RULE NO.: R161-23.11

NOTICE OF RULE ADOPTION

TEXT OF ADOPTED RULE

R161-23.11: Notice of Adoption to Section 800 in the Standard Specifications Manual does contain changes from the proposed rule.

Figure 1

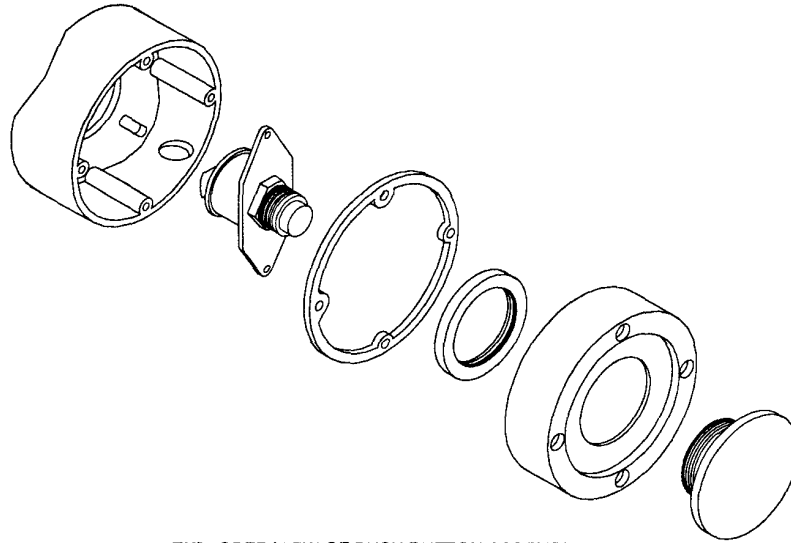
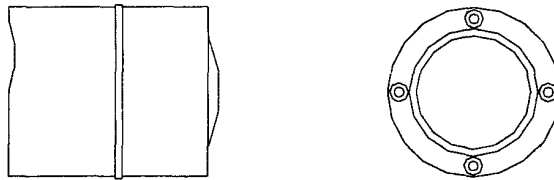
The Push button assembly shall be fabricated with design characteristics shown in Figure 1

The push button switch shall be actuated by a minimum 2" ~~(50-mm)~~ diameter plunger. The plunger shall have an integral shaft to actuate the switch and have a clear anodized finish. The assembly shall be designed so that the maximum plunger travel does not exceed the switch travel. A spring shall be installed between the plunger and switch. The spring shall provide an operating force of less than 5 lbs ~~(22.2 newtons)~~. A
